Application Ref: NP/20/0574/FUL

Case Officer	Kate Attrill		
Applicant	Mr D Hughes		
Agent	Hyde & Hyde Architects		
Proposal	New replacement residential dwelling		
Site Location	Bettws Bach, Parrog, Newport, Pembrokeshire, SA42 ORX		
Grid Ref	SN04663968		
Date Valid	18-Dec-2020	Target Date	09-Jun-2021

Item 5 - Report on Planning Applications

existing north elevation

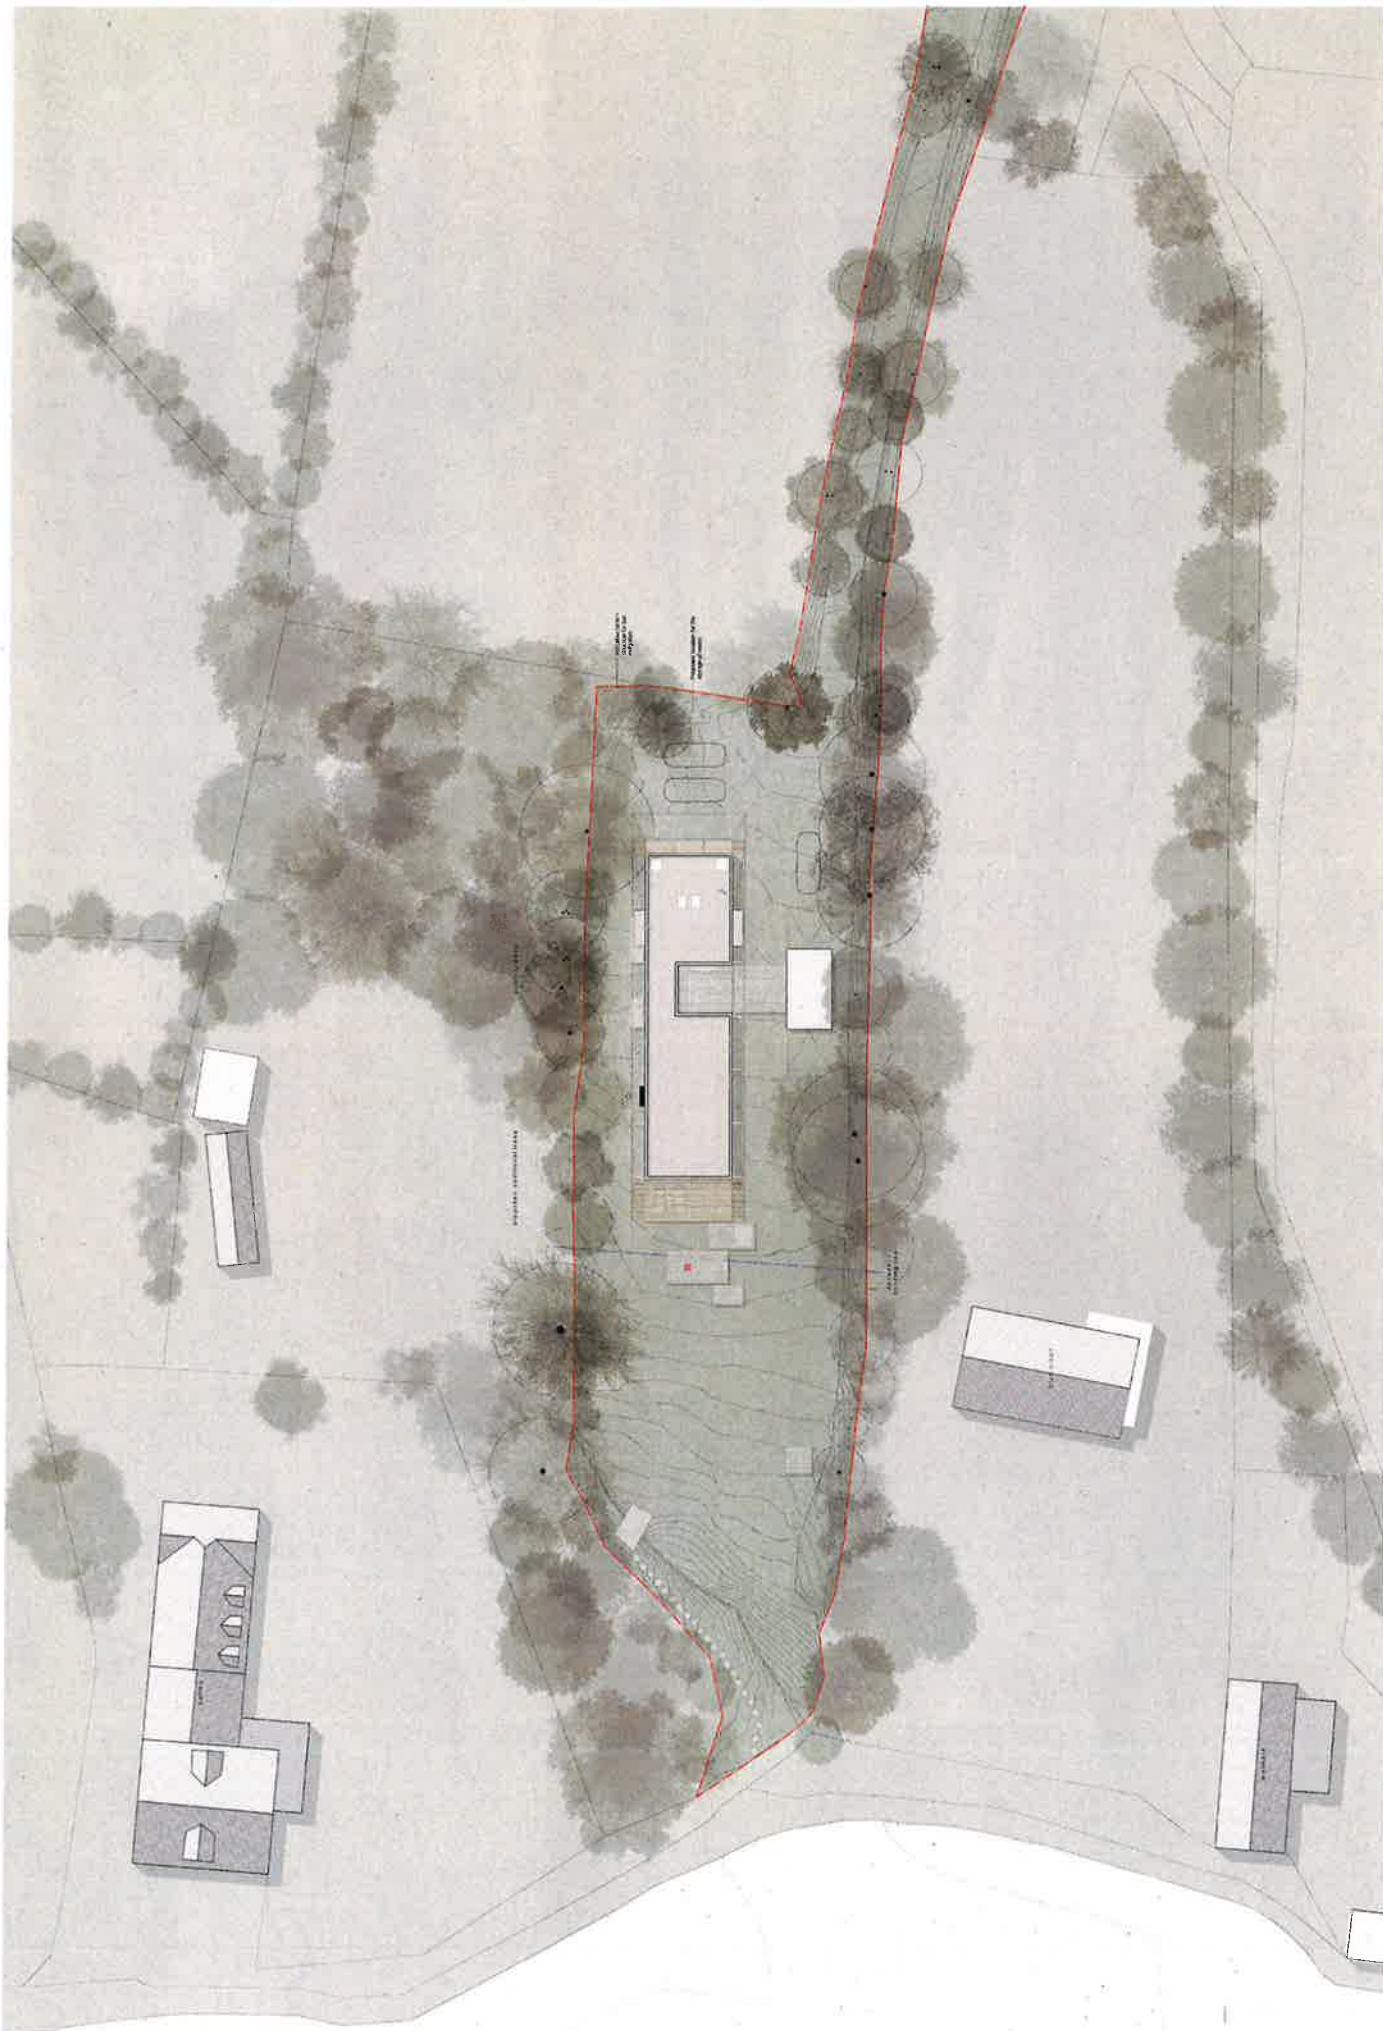
The applicant's agents have submitted a 'dusk visualisation' showing the potential impact of the proposed glazed northern elevation facing towards the coastal path. Whilst this appears to show an acceptable level of lighting, it is only a visualisation, and there has not been submitted an internal lighting scheme to confirm this impact. Were this application to be supported, it would need to be discussed as to whether an internal lighting condition would be reasonable and enforceable under the tests for planning conditions.

'1. From views across the estuary and the estuary itself, it would appear that the house will be visually recessive, arguably more so than the solid rendered existing building. Landscaping and control of light are critical here – the latter due to the large expanse of glazing to the façade. Subject to the above, the estimated impact will be low.

3. Before development commences details of external illumination, including measures to control light spillage, shall be submitted to the National Park Authority for approval, in writing. Development shall be carried out and maintained in accordance with the approved details.
Reason: To ensure that animal and plant species which within the terms of the Conservation (Habitats 2c) Regulations 1994 are effectively protected and the Local Development Plan – Policy 11 - Protection of Biodiversity.

existing east elevation

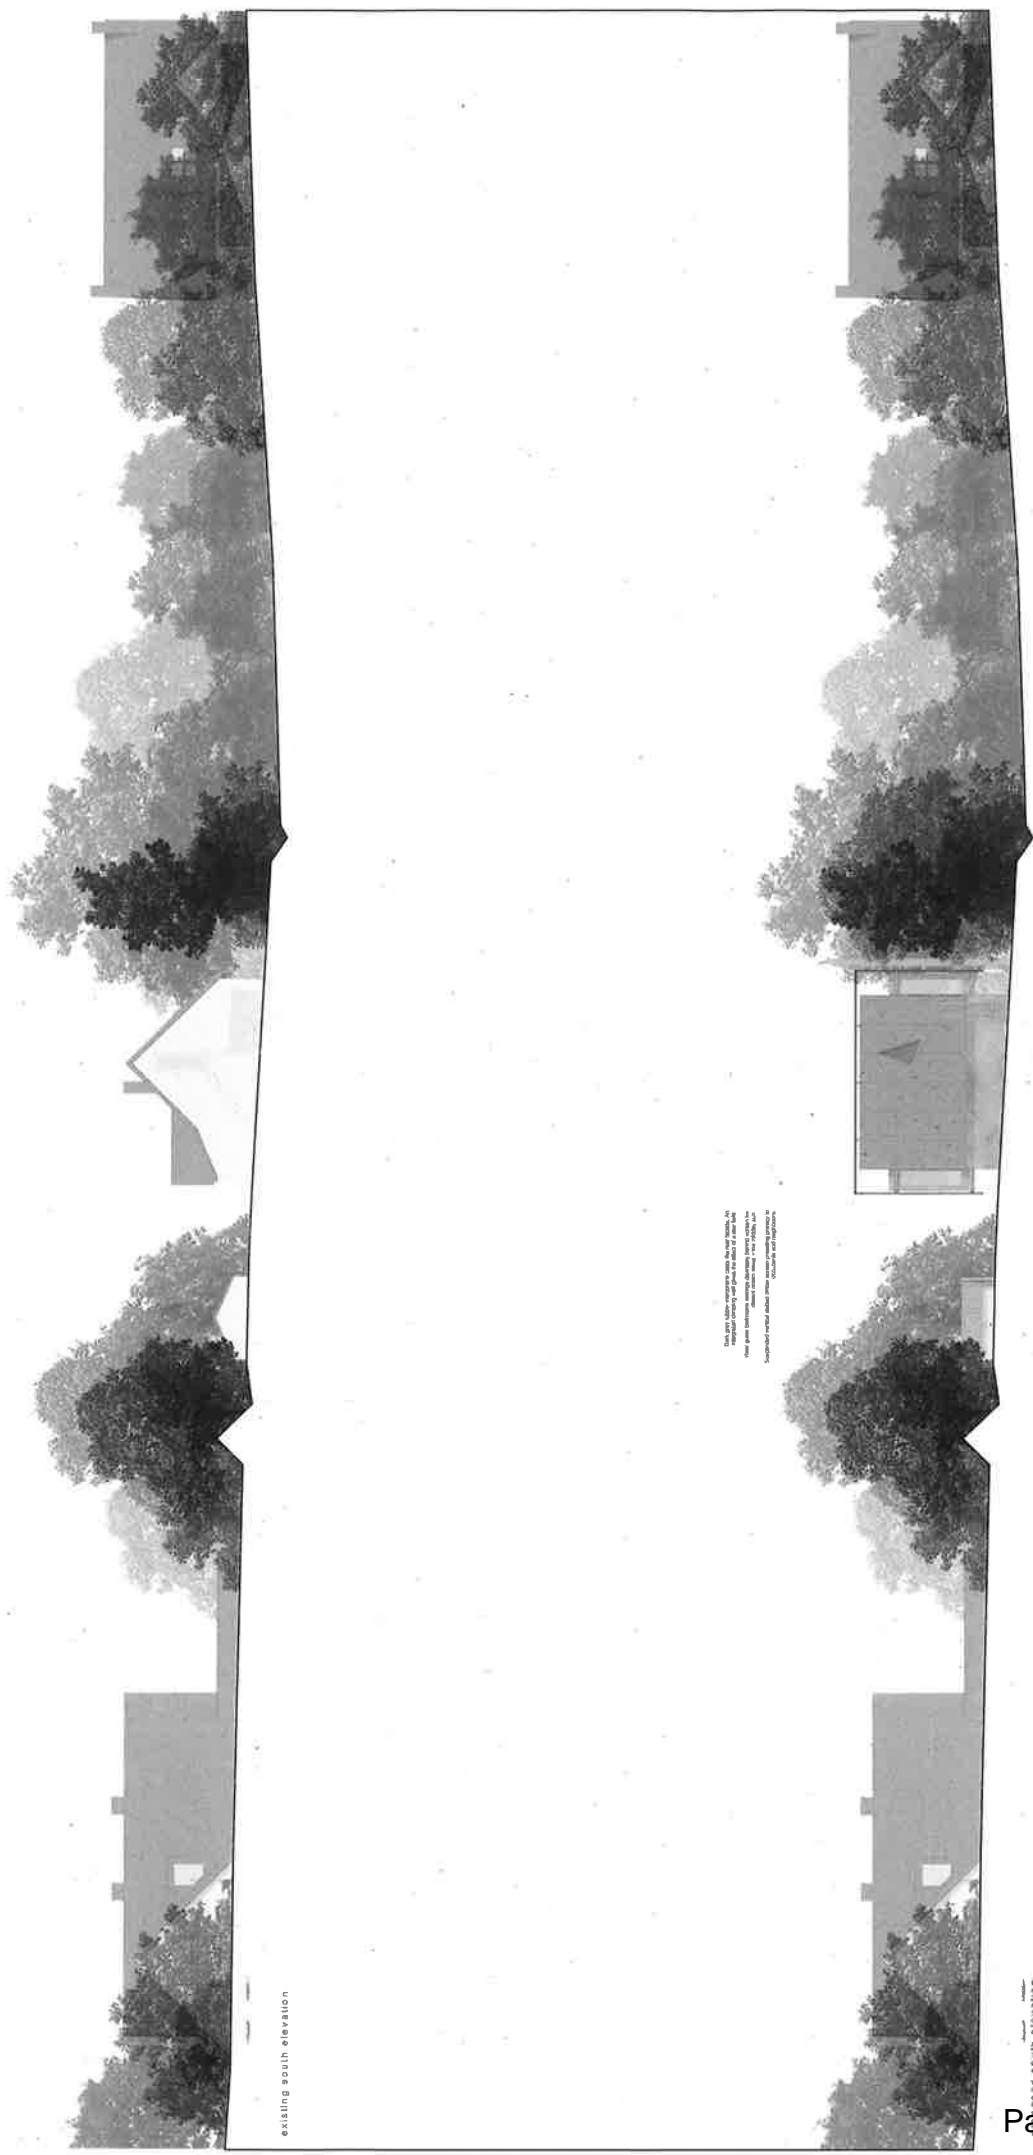
The dwelling proposed has its first-floor windows screened by vertically hung timbers to the west and east, with only a single first floor window visible on the eastern elevation. The eastern window will not overlook the adjacent dwelling. No third-party representations from adjoining neighbour have been received during the course of this application.

4. The dwelling shall not be occupied until such time as the external timber louvres (as shown on plans 18104_HHN_P10 & 18104_HHN_P12) have been fitted. Once complete, the timber louvres shall be retained as such in perpetuity.
Reason: In order to ensure the dwelling remains recessive in the landscape, and to protect the amenity of adjoining occupiers in accordance with Policies 8, 14 & 30 of the Pembrokeshire Coast Local Development Plan.

existing west elevation

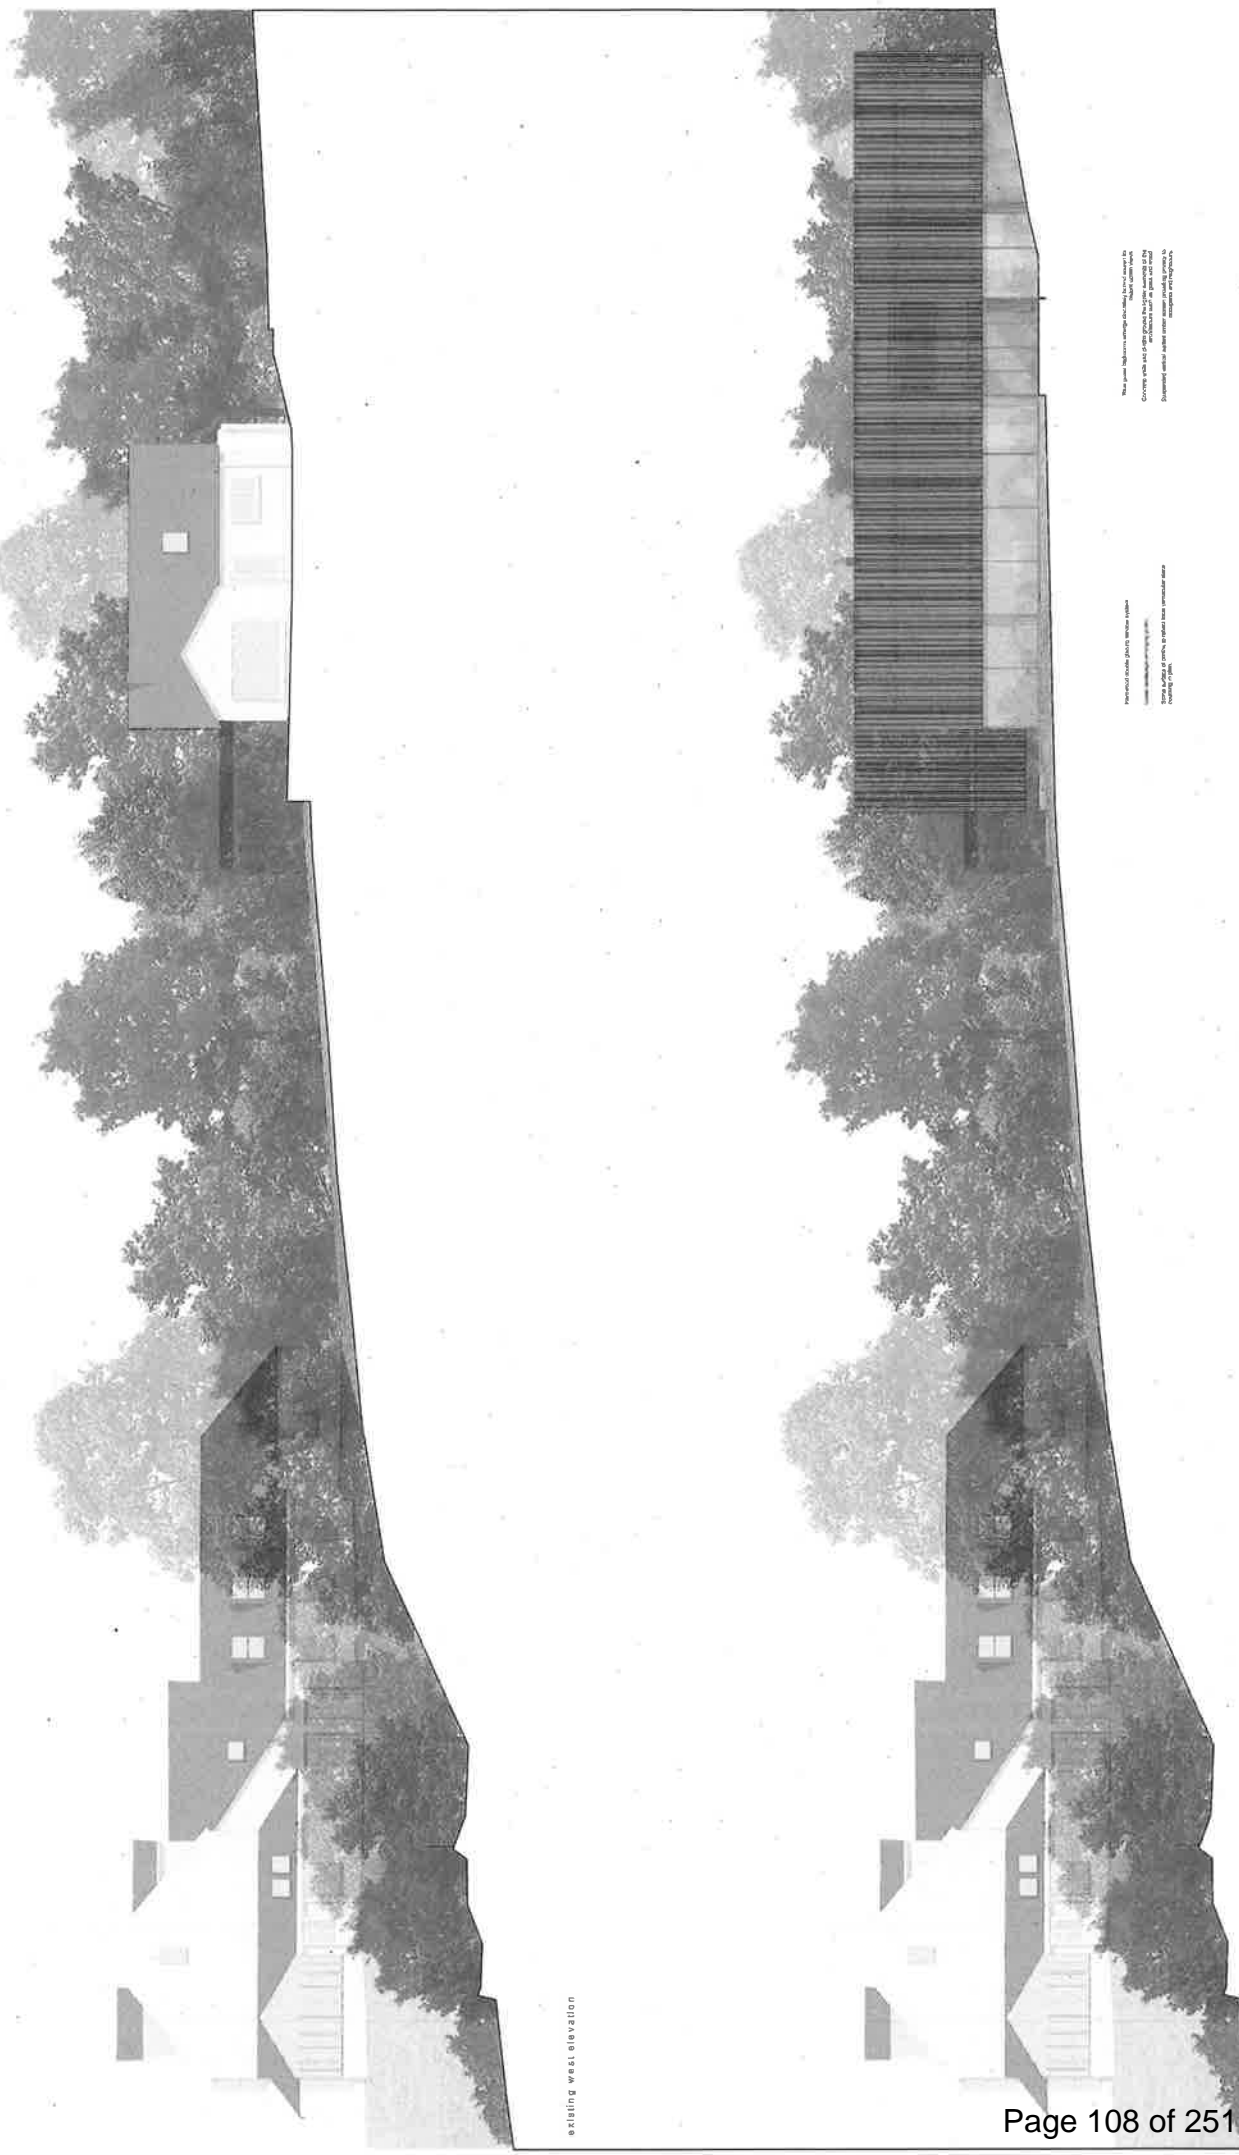
2. Closer views of the side elevation of the house will exist from the footpath to the west, part of a well-used network of paths connecting the town to the Parrog. Side-on, the proposed dwelling is large and rectilinear, more like a factory building than a dwelling (that is no criticism of the intrinsic design). Together with closer views from the Coast Path, I feel the context is wrong for a replacement dwelling of this design and scale. The house is large and uncompromising here and whilst the

Whilst having no objection to the demolition of the existing dwelling and no objection in principle to a modernist replacement, my view is that the development as proposed would not preserve the character or appearance of the conservation area. I therefore object to the proposal on this ground.'

However, following a site visit on the 16th April the Conservation Officer has revised his comments: *Further to our site meeting with owner, agent and architect on 16/04/21 and further visualisations received from the agent today, the level of impact is now much clearer. With the reduced levels and setting-back of the property, the impact will be very low when viewed from the coast path/opposite side of the estuary/rear access road. The trees/hedge alongside the footpath to the east gives further screening, plus the intervening hedge and proposed garage.*

*Subject to an appropriate condition retaining/enhancing the eastern boundary of Bettws Bach, I am now content that the impact on the character and appearance of Newport Parrog Conservation Area will be low and (superseding my previous comment) am content to **support** the proposal.'*
